BELL BEND NUCLEAR POWER PLANT
RESPONSE TO RAI No. 37 AND
SCHEDULE INFORMATION
BNP-2009-244 Docket No. 52-039

References: 1) M. Canova (NRC) to R. Sgarro (PPL Bell Bend, LLC), Bell Bend COLA – Request for Information No. 37 (RAI No. 37) – SEB1 -2659, 2660, 2661, e-mail dated July 27, 2009

Response to NRC Request for Additional Information No. 37
Bell Bend Nuclear Power Plant

FIGURE 1-8

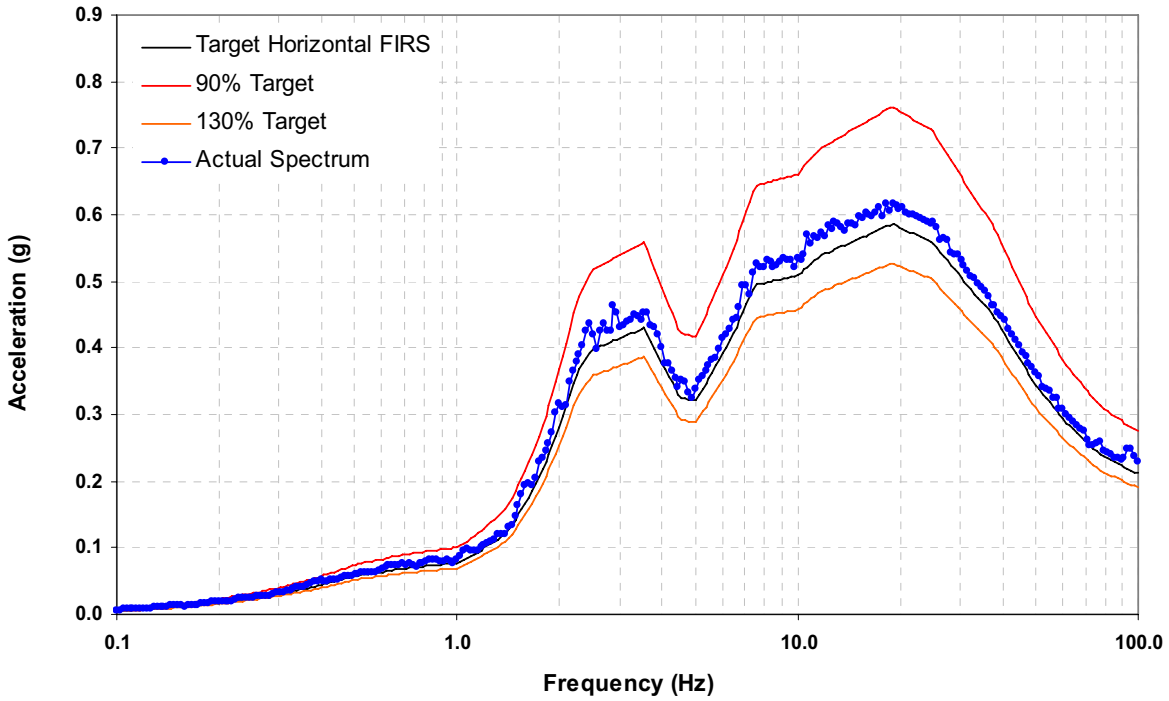
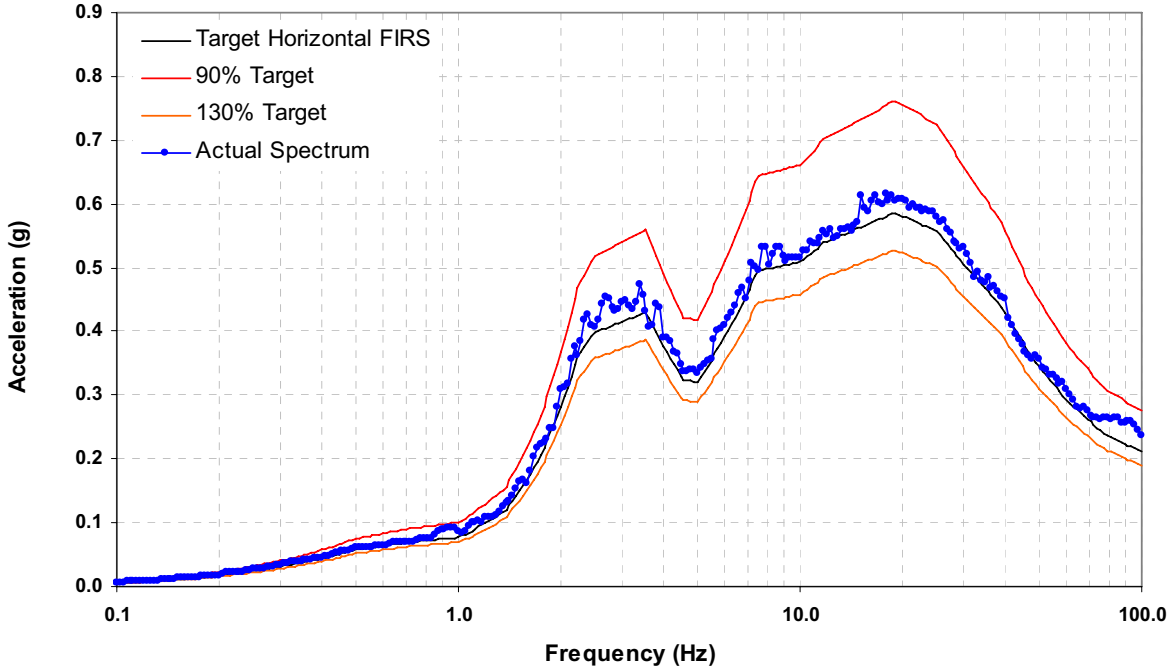
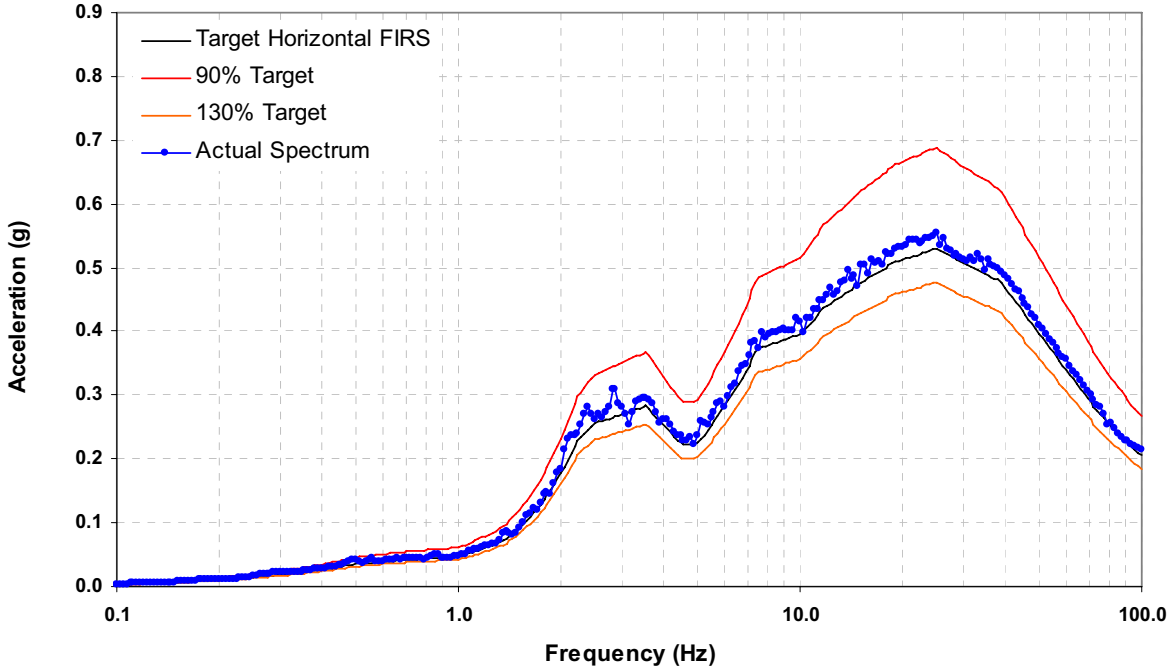
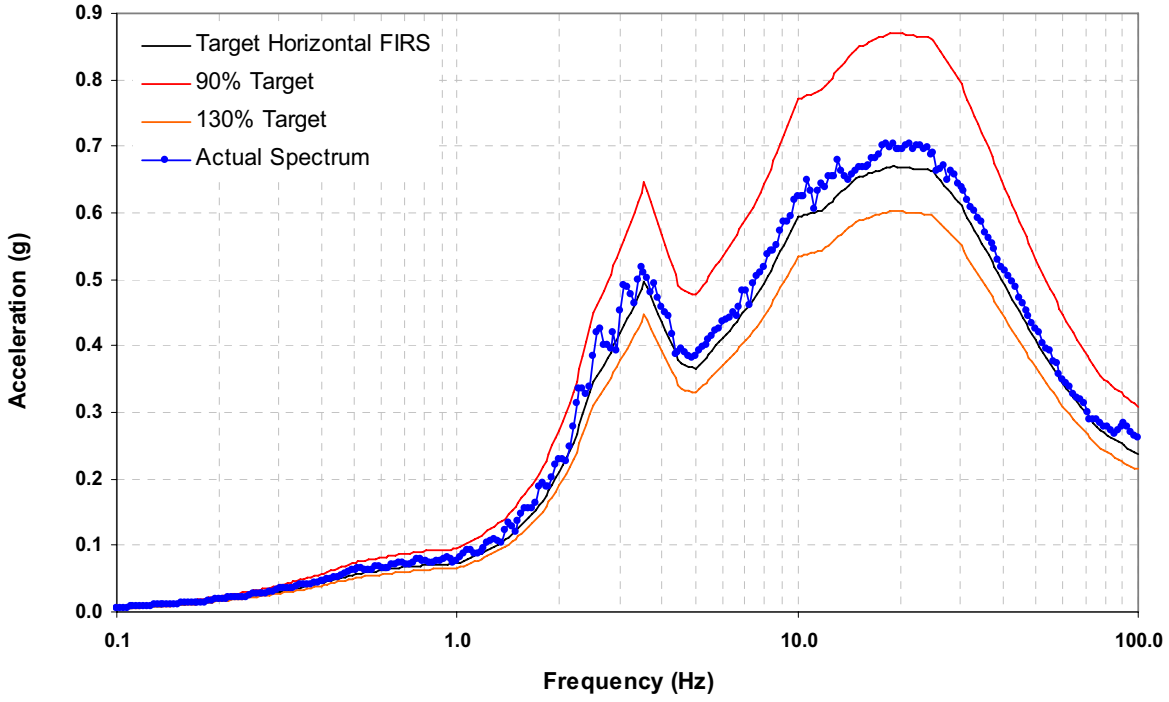
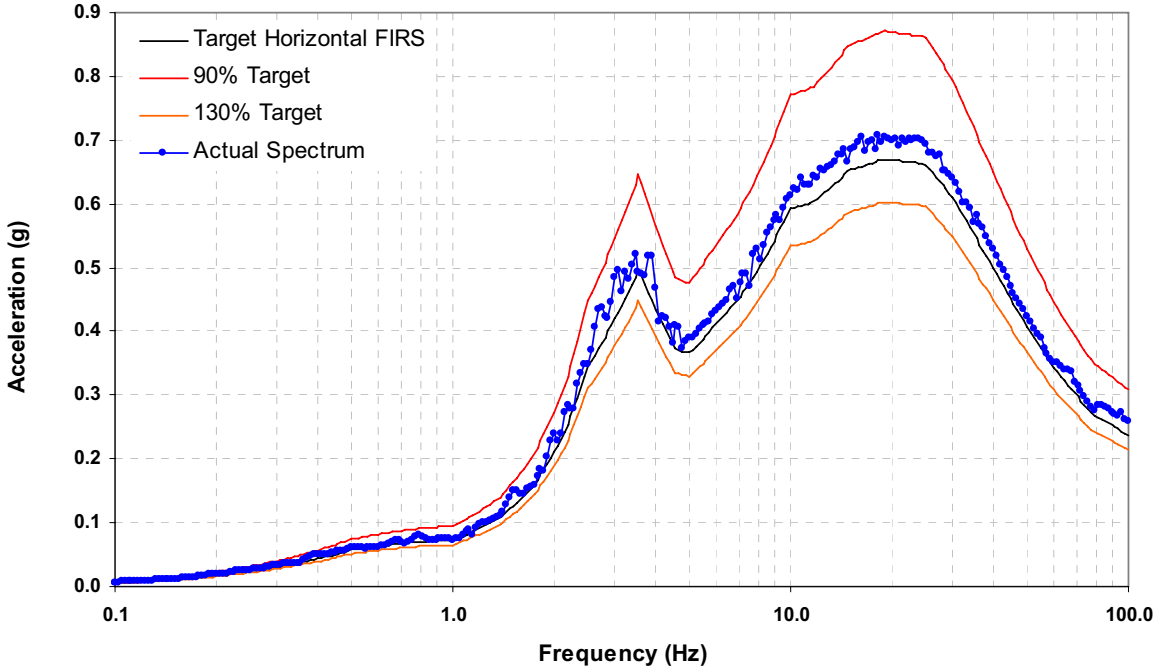
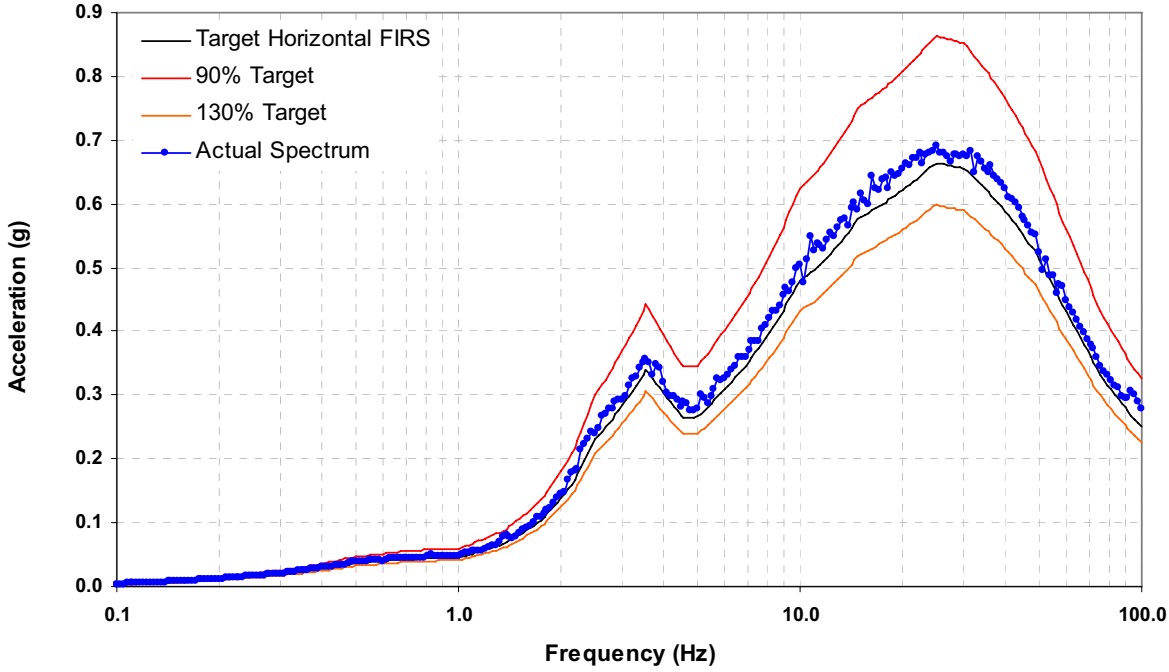
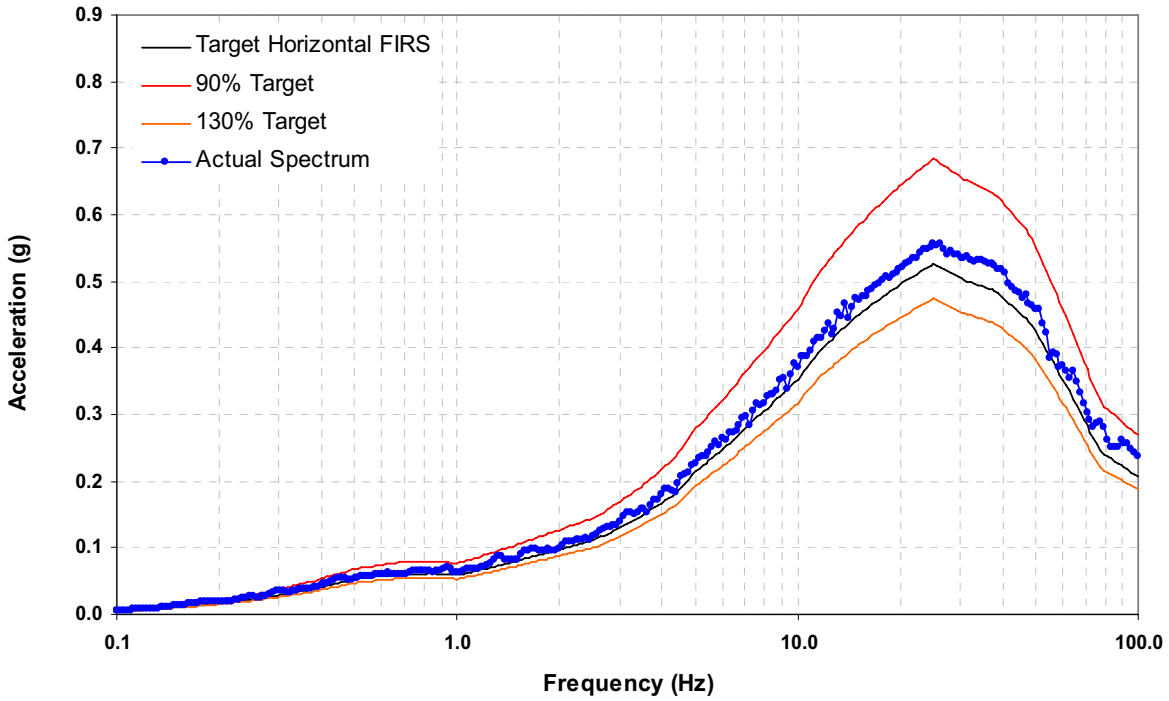
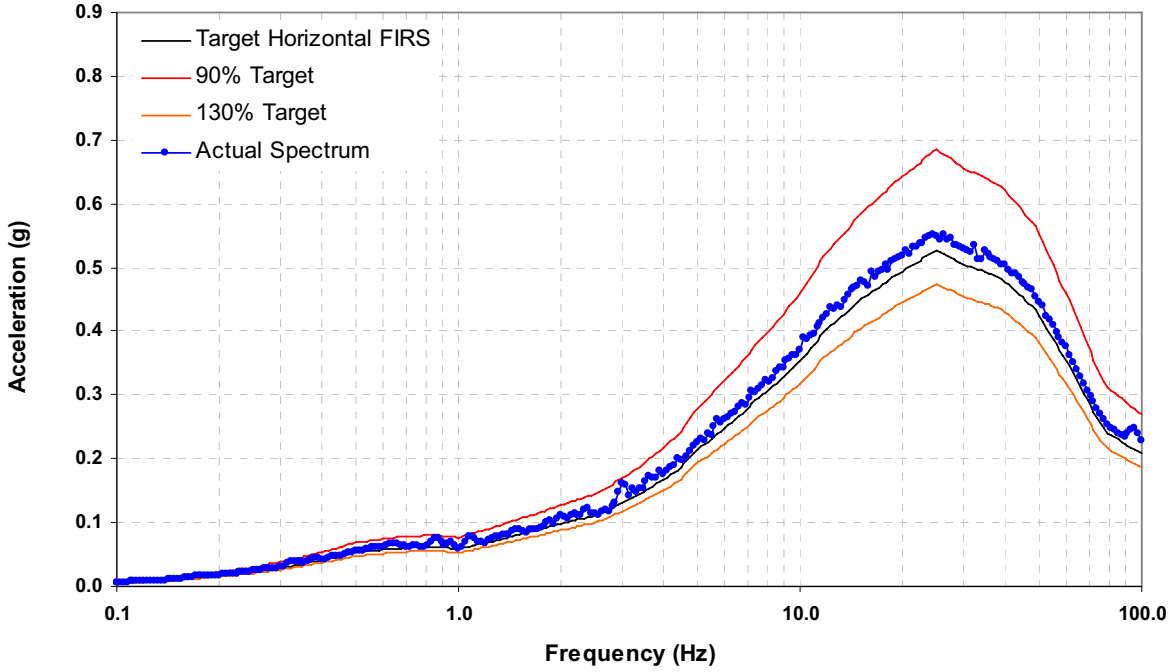
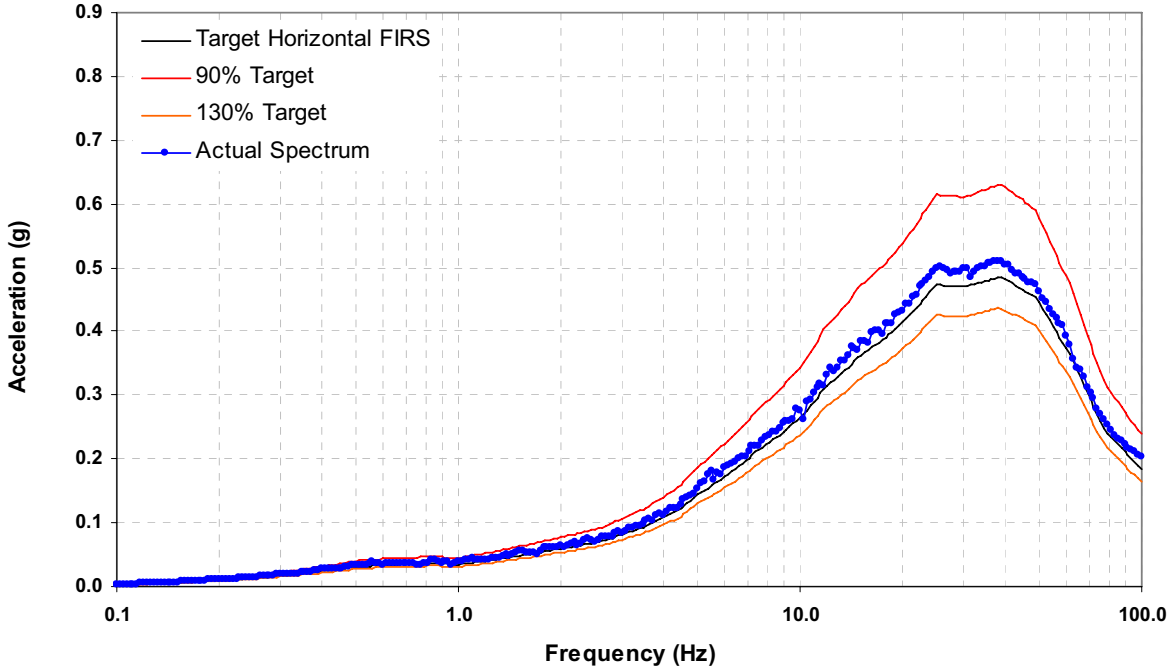
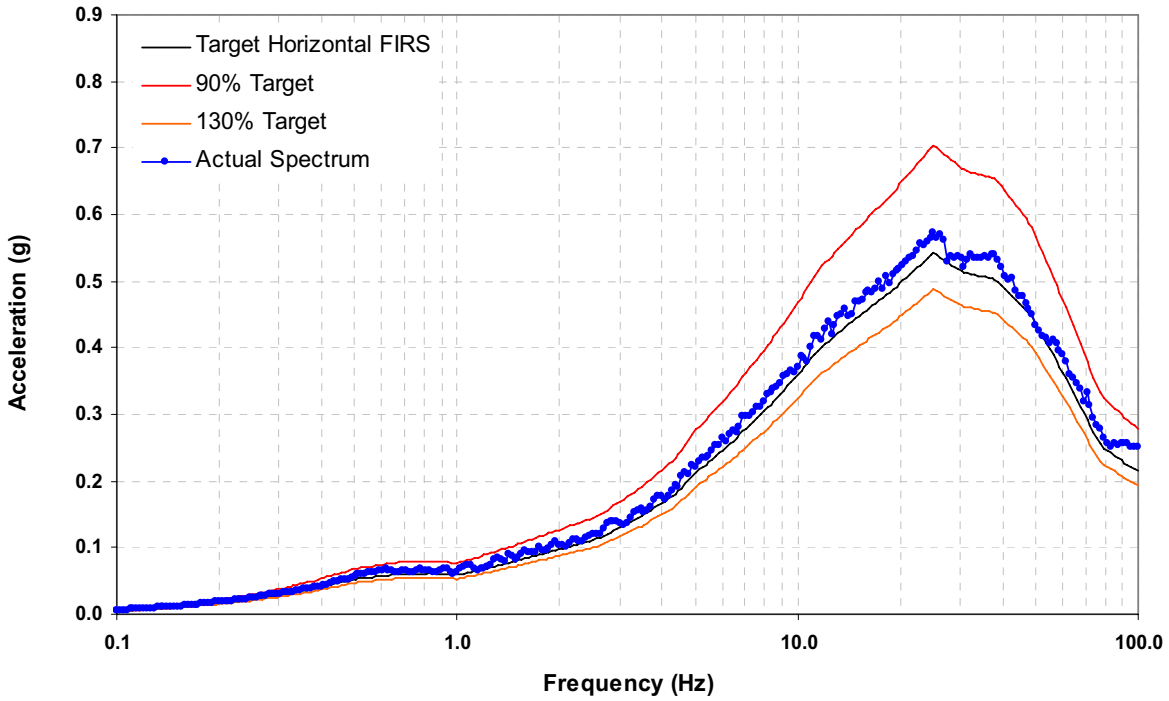
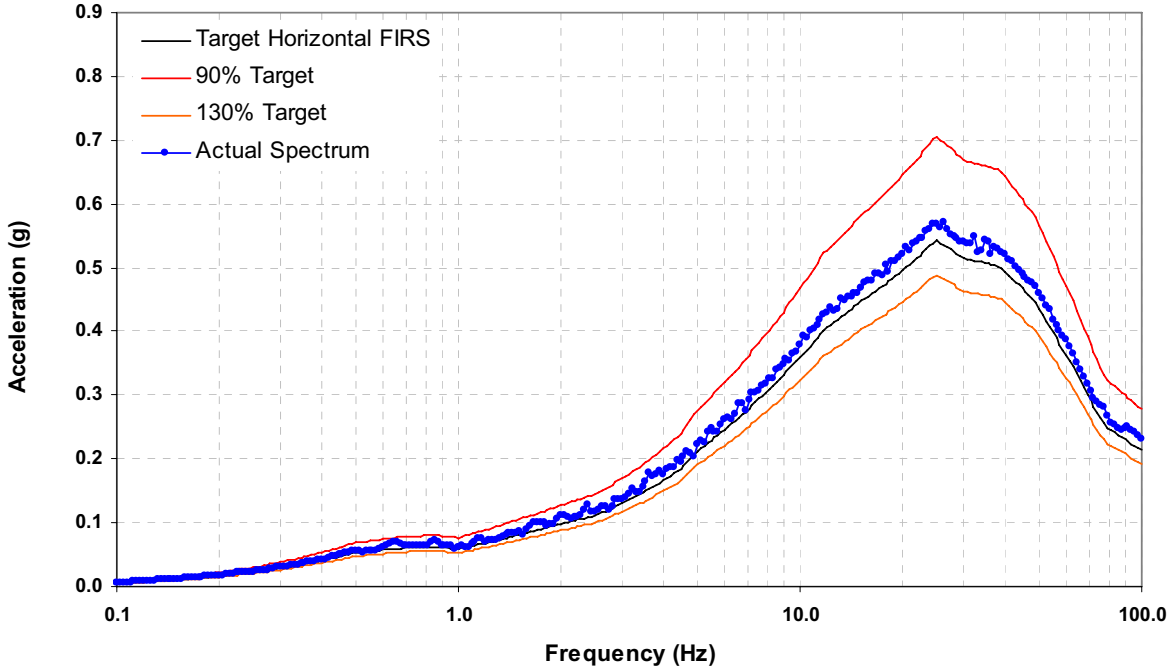
3) Describe the ground motion input time histories that were used in the SSI analysis and how they meet SRP Acceptance Criteria 1.B of SRP Section 3.7.1. In addition, provide a comparison of the response spectra of the input time histories to the FIRS for each of the structures and demonstrate how the response spectra of the input time histories meet Approach 1 or Approach 2 of SRP Acceptance Criteria 1.B of SRP Section 3.7.1.

Response
Figures 1-8 through 1-22 show the comparison of the 5% damped response spectrum of the input time histories, and 90%, 100% and 130% of the target response spectra for five structures (3URB, 4URB, 12URB, 12UBP, 34UBP). The comparison demonstrates that the 5% damped response spectra of the time histories do not fall more than 10% below the target response spectra, and do not exceed the target response spectra by more than 30%.
